September 14, 2017

Subject: Revised Plan to address Direct Contact Risk and Plan to Evaluate Offsite Vapor and Groundwater Conditions, Village of Whitefish Bay Landfill, 5201 West Good Hope Road, Milwaukee, WI

License Number 356
FID: 241218670
BRRTS: 02-41-000254

FIGURE 1

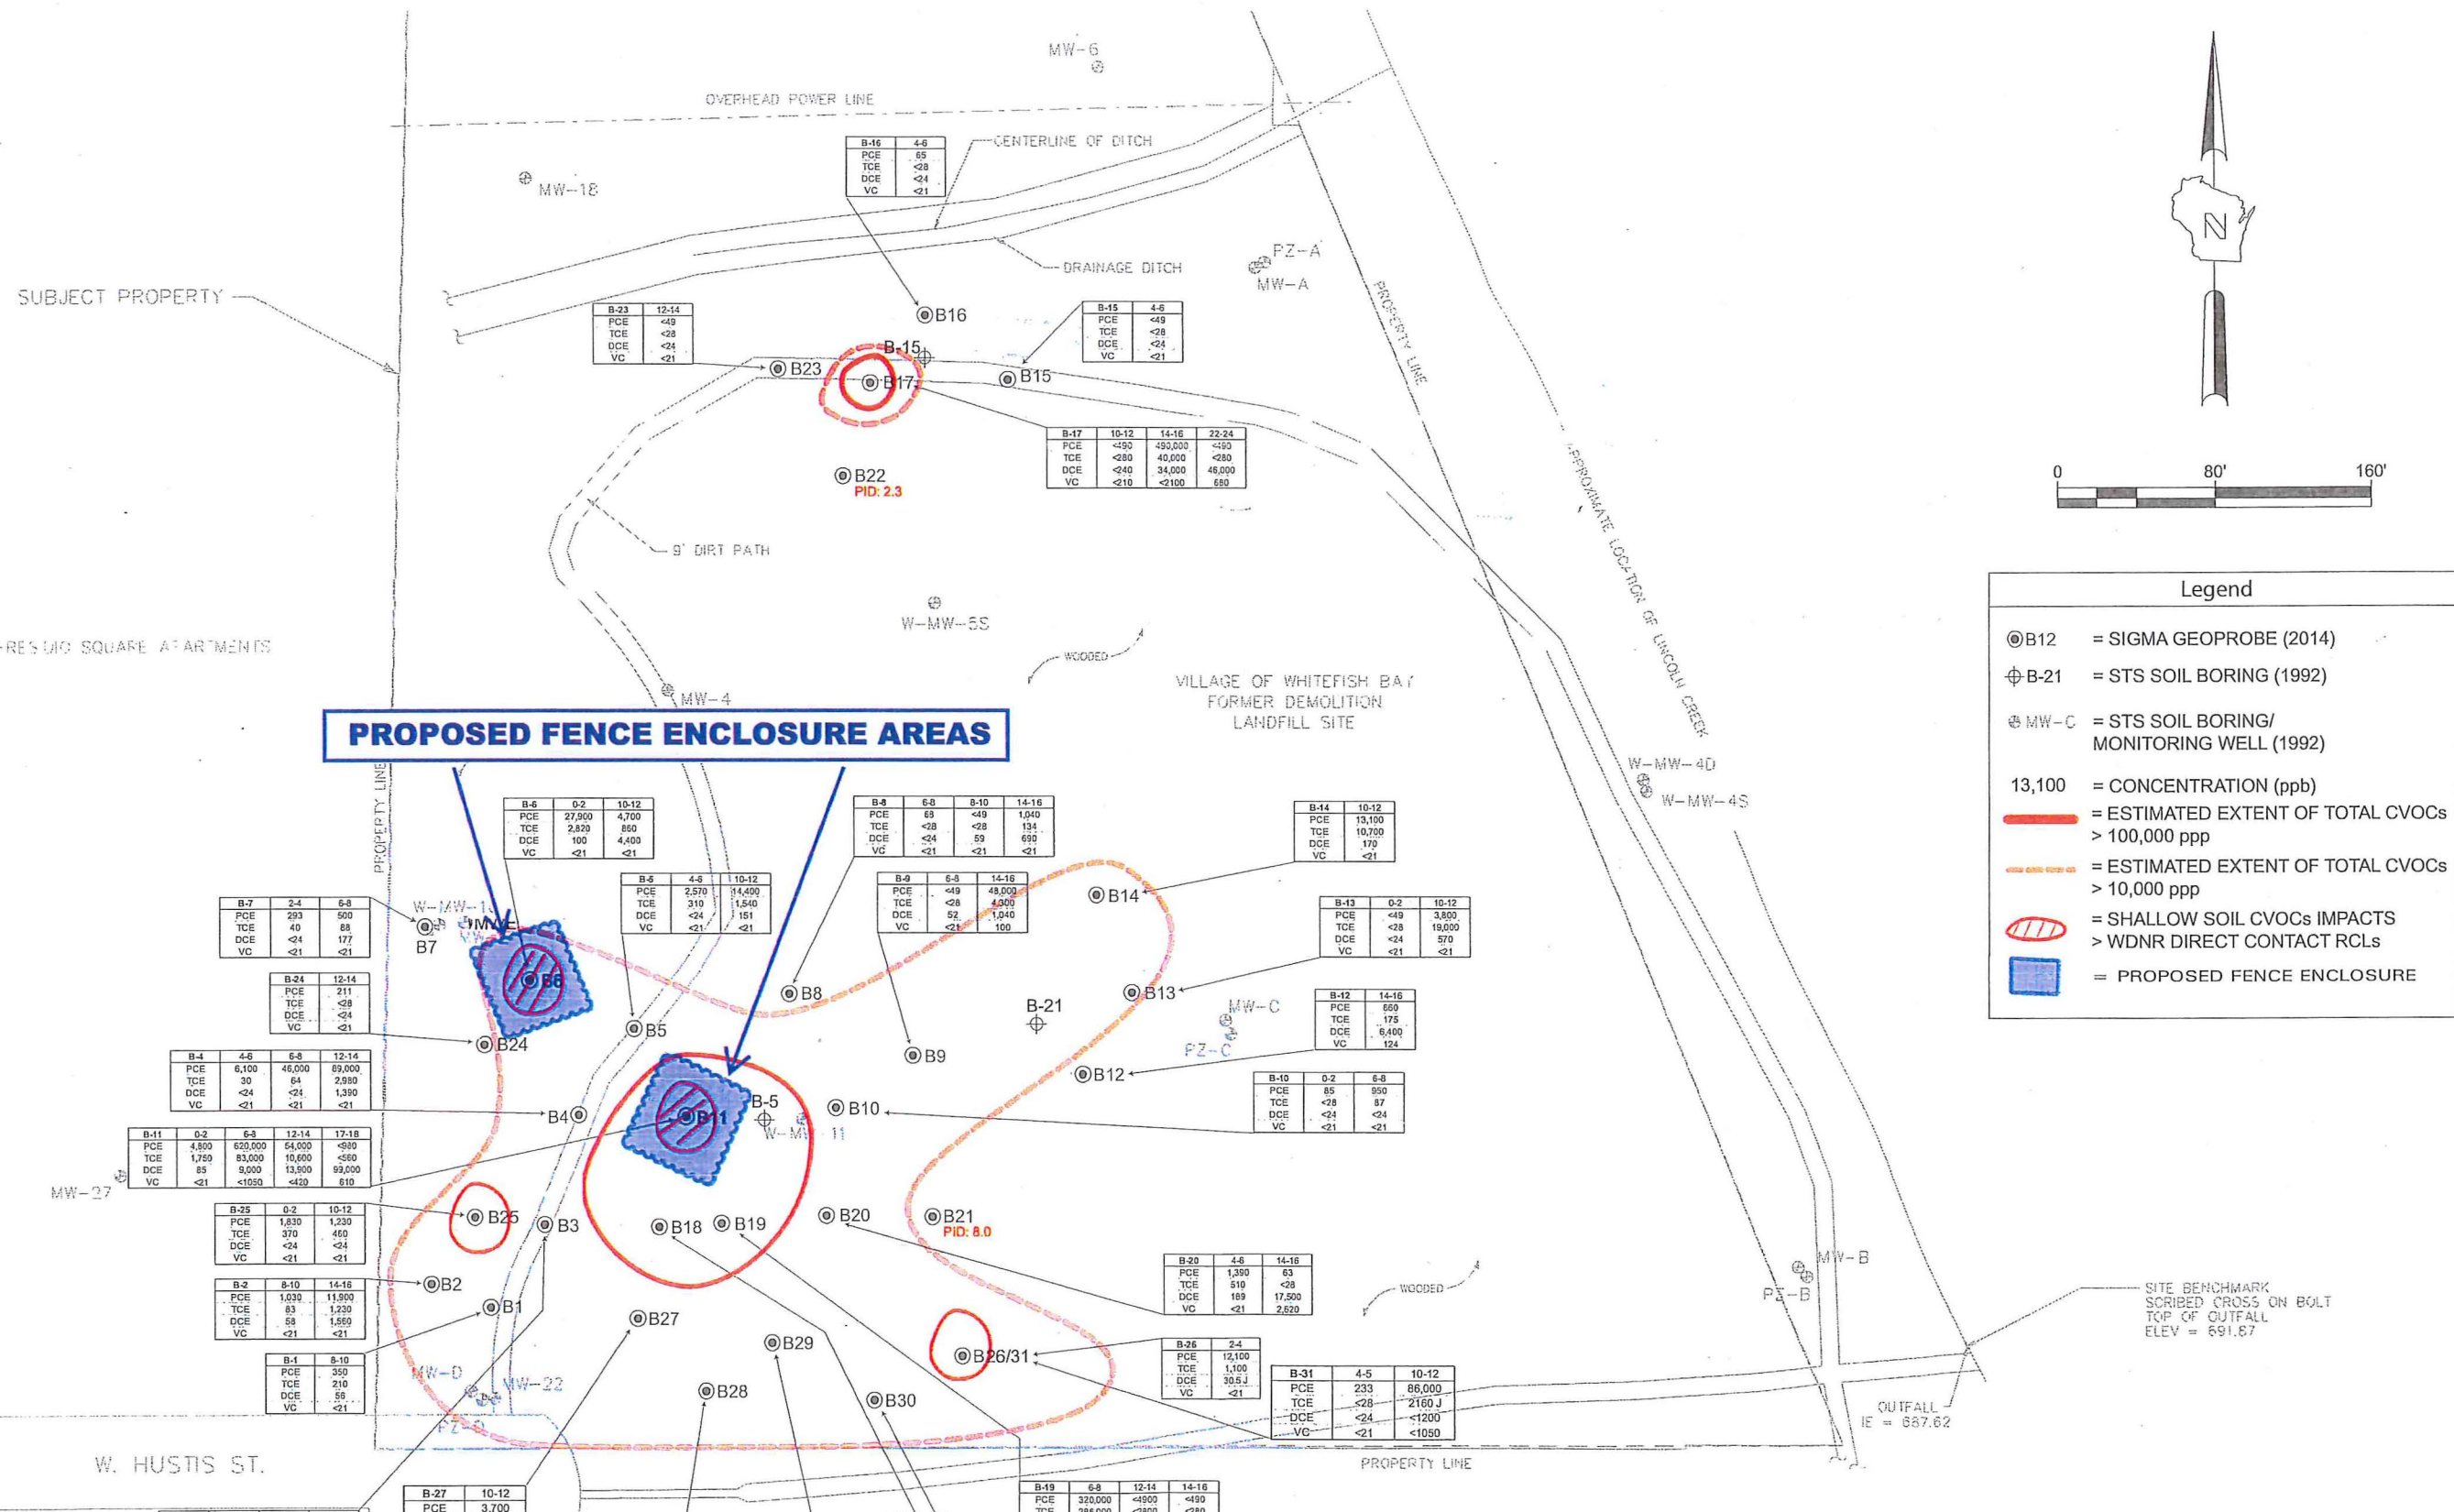
Instead of a direct contact cap or removal of shallow impacted soil Sigma proposes to install chain-link fence enclosures around the identified shallow soil impacted areas as shown on the attached map Figure 1. The chain-link fence will be approximately 10-feet high around each of the areas with appropriate warning signs and lockable gates. A maintenance plan will be implemented to inspect the fence every spring to assess any damage during the previous seasons and implement any repair work. The objective of the fence enclosures is to prevent any unauthorized entry within these areas and allow needed access for any future work for monitoring and/or remediation work.

Note: The DNR considers the use of the chain-link fences as an interim action for the site that doesn't fully address soil and groundwater contamination at these locations. This temporarily addresses the direct contact issues in the designated areas but, it doesn't address infiltration into the groundwater from the contaminated soils. Future remediation activities may require soil removal and/or groundwater remediation after selection of an acceptable remedial action per ch. NR 722, Wisconsin Administrative Code (WAC) for the property and additional remediation activities offsite depending on the results of future evaluations.

FIGURE 2

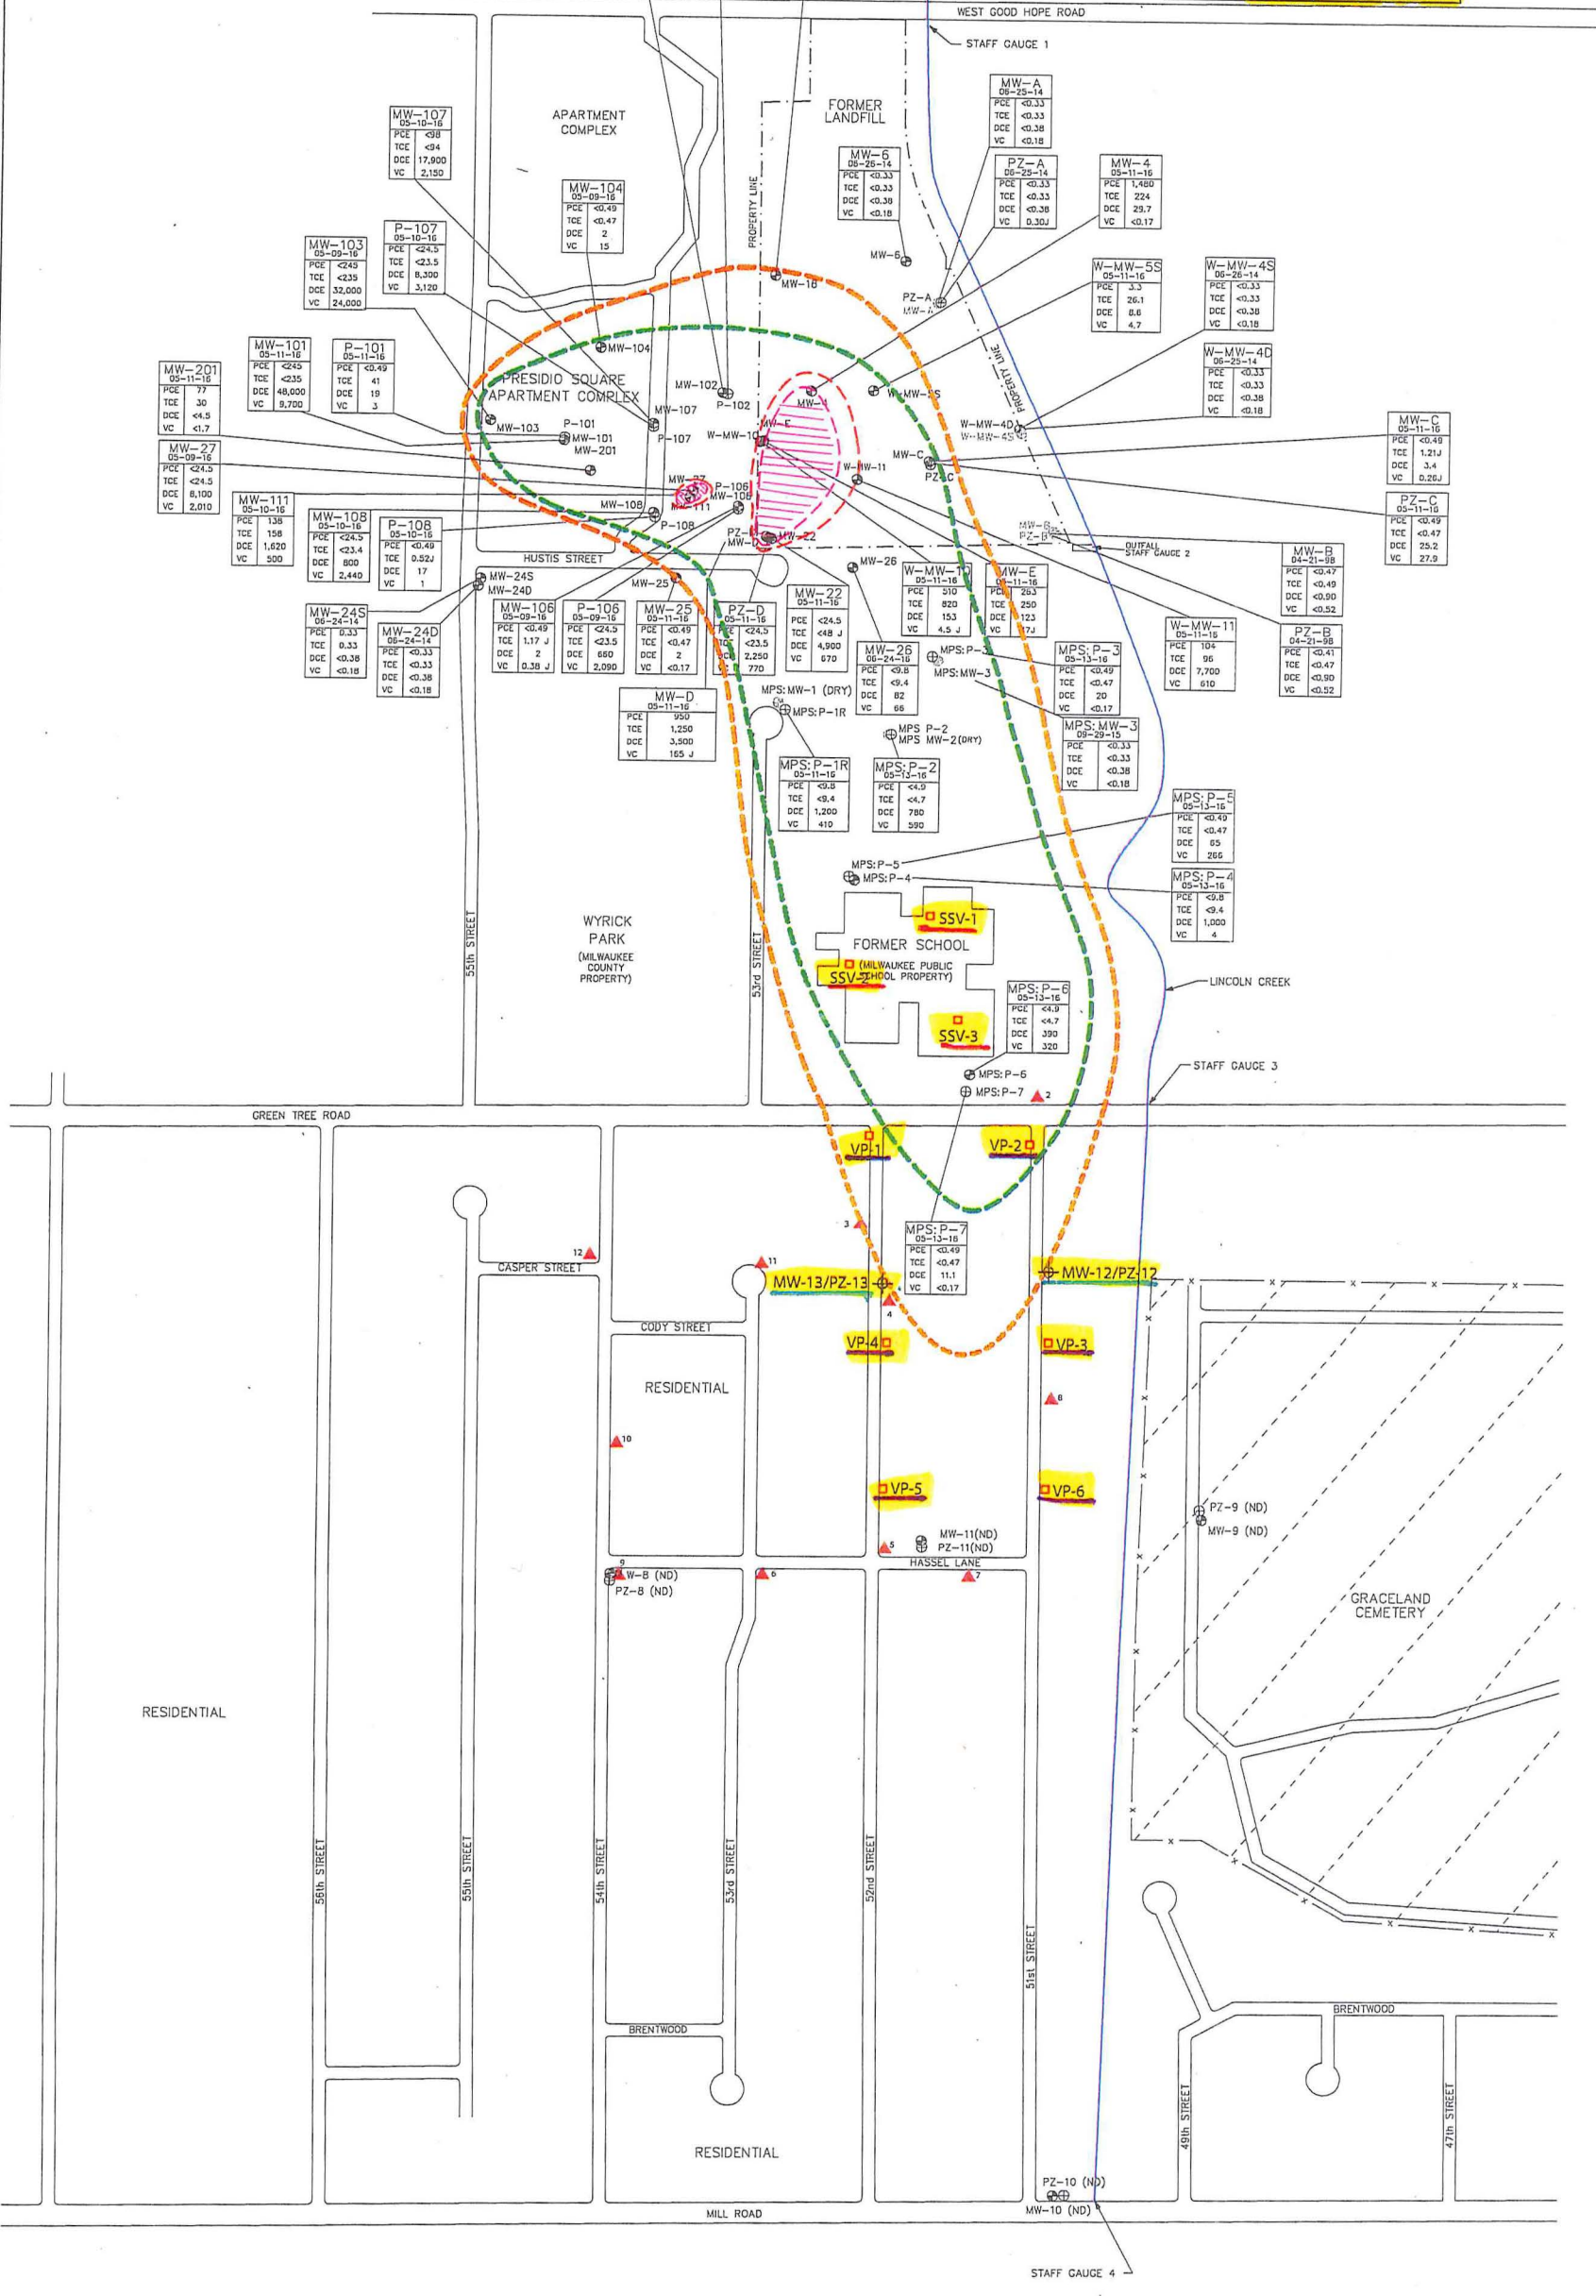
Sigma proposes a vapor assessment to evaluate the subsurface conditions at off-site downgradient locations. Subslab samples SSV-1 through SSV-3, will be completed at the former Milwaukee Public School and soil vapor samples from locations within the residential subdivision along the city street right-of-way as shown on the attached Figure 2.

Note: Future maps should include the residences and Presidio Apartments on the maps to better understand what properties are being affected by the contamination. For the off-site soil vapor assessment along 51st and 52nd Street, the DNR recommends that vapor points VP-1 through VP-6 should “line-up” with the nearest residence in order to be as close as possible to each house in the right-of-way to better assess any vapor potential.

Sigma proposes to further define the groundwater contamination plume within the residential subdivision by installing two ch. NR 141, WAC, compliant monitoring well nests MW-12/PZ-12 and MW-13/PZ-13 at locations indicated on the attached map Figure 2, to the appropriate depths as discussed in their proposal.

The DNR approves Sigma’s proposal. Additional on- and/or offsite investigation, evaluation, or remediation may be required depending on the results from this proposal.
